U.S. DEPARTMENT OF AGRICULTURE  
NATURAL RESOURCES CONSERVATION SERVICE  
Minnesota  
January 12, 2009

ENGINEERING REPORT

**Project:** Kellen Grade Stabilization Structure

**Location:** Big Stone County, Minnesota

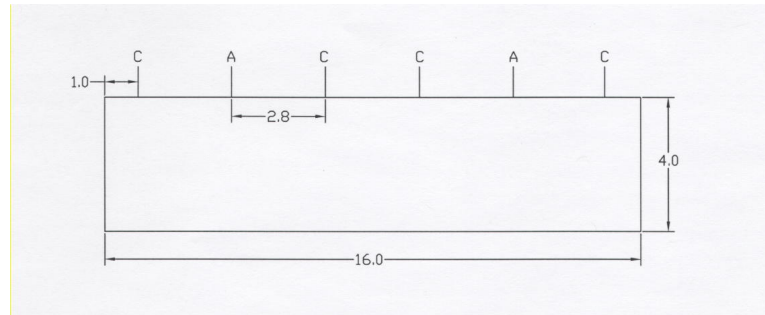
Anchors. Gary Blough stated that during construction the duck billed anchors were driven to their full depth, pulling the concrete mat cables down snug. At first, on the bottom of the chute, they set the anchor by attaching a chain to the cables and pulling up with a back hoe. They stopped setting the anchors further up the chute, thinking that any uplift of the blocks would set them anyway.

The locations of the anchors were marked by the committee using spray paint. They appeared to follow the locations shown on the drawings. Additional anchors placed after the 2005 event were found along the center of the chute. One of the anchor cables at the upstream edge of the detached blocks was able to be pulled out of the ground by a member of the investigating committee. It was in the ground its full length but apparently the cable had been broken. Its end was frayed. We asked those personnel present during construction if this could have been caused during the setting of the anchors. They did not think the damage could have occurred during construction because the broken cable would have been very obvious when the anchor was set.

2008 Displaced Blocks  
Subsidence along RDS toe

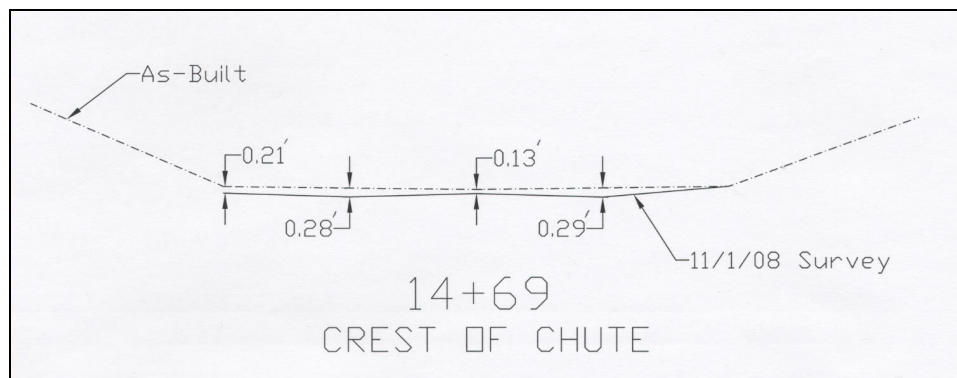
Using a tile probe, approximately three inch deep voids were found under the blocks and geotextile inside of the toes of the chute. These voids started approximately  $\frac{1}{4}$  of the way down the chute and extended to the chute bottom.
